**ADDENDUM TO RFP DOCUMENTS**

ADDENDUM # 03
	SCCD RFP: # 14-014
	Project: Solano Community College District Theater Renovation
	Date: 08/13/2015

**Addendum # 03 – The following clarifications are provided based on questions received and must be added/considered when completing your submittal:** Acknowledgement of receipt of this **ADDENDUM** is required in the proposal’s cover letter of introduction. Please clearly note the addendum date and number.

HAZ.01

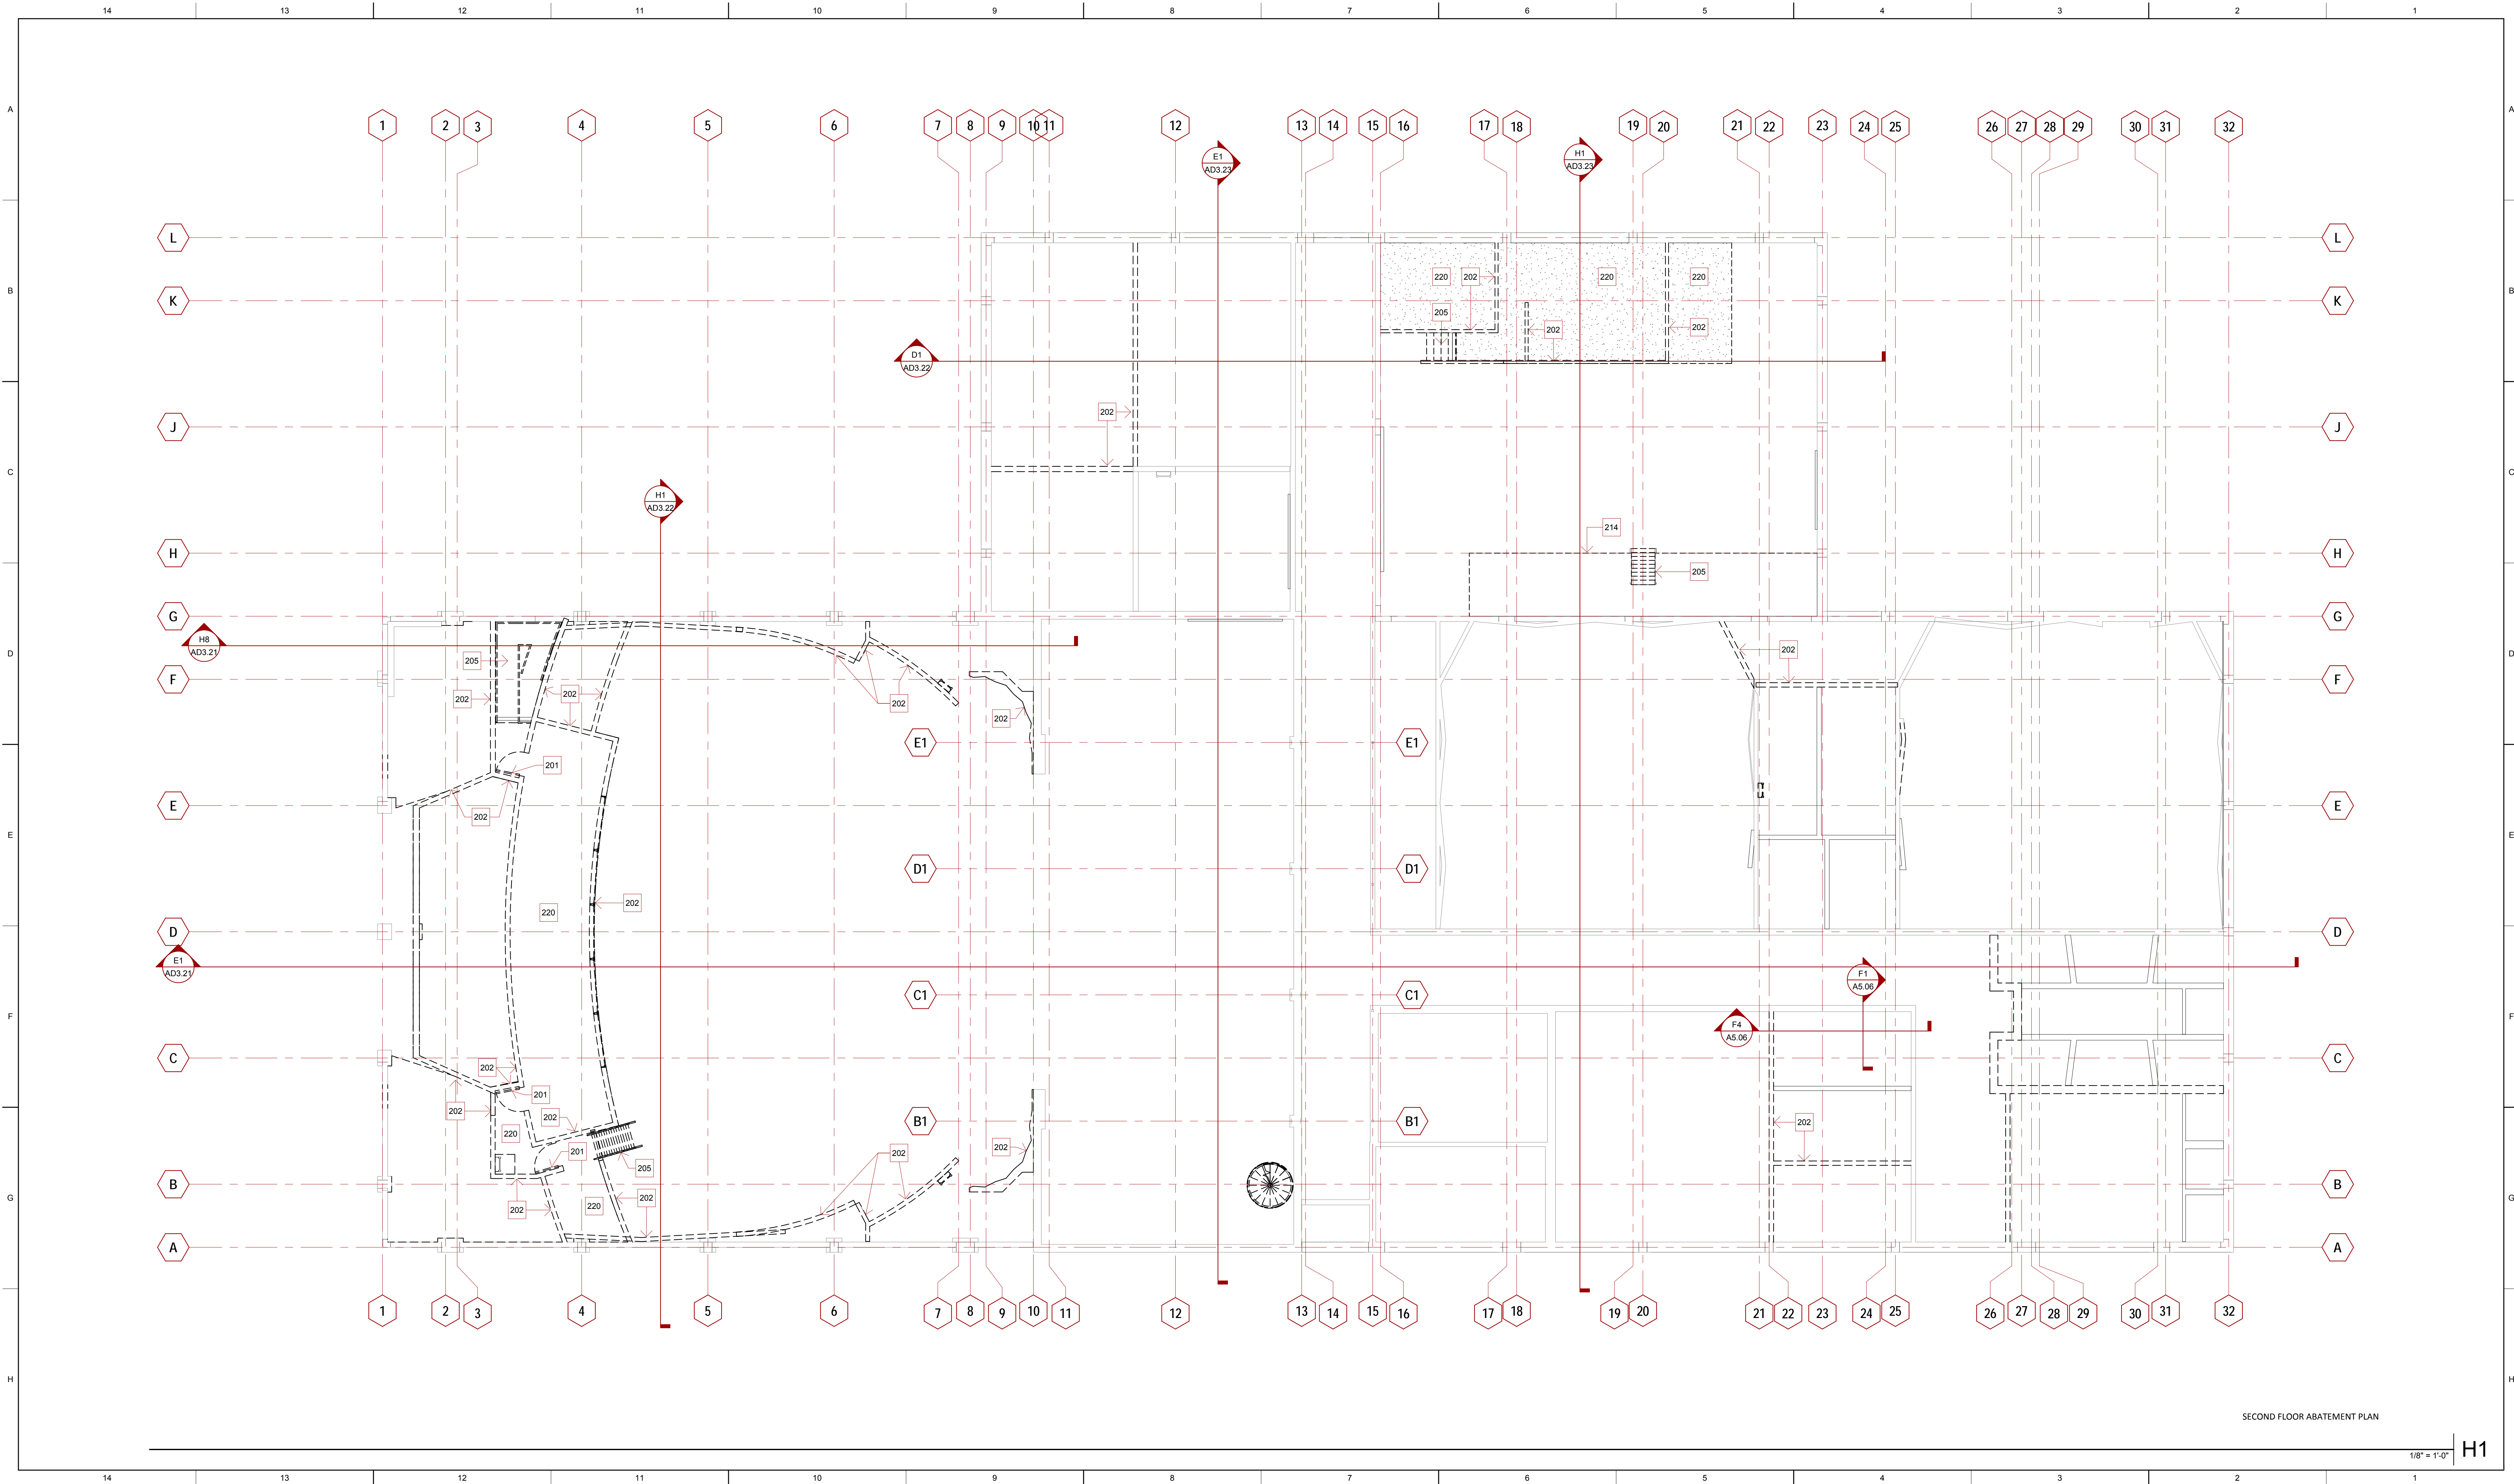
1. Hazmat Sheets HAZ.01 and HAZ.02.
  - Sheets were revised and included in Addendum 01, but not listed on the Addendum 01 narrative. Changes indicated in Keynotes.
2. Hazmat Sheet HAZ.03
  - Removed in Addendum 01. Added back into project in this Addendum (03) as it appeared prior to Addendum 01. No change to drawing.

- a. Narrative for addendum # 1 does not show the revised drawings that are part of the package. HAZ .01 and HAZ .02 have been revised in addendum #1

Response: Addendum 3 includes the above mentioned drawings. These drawings are part of the project.
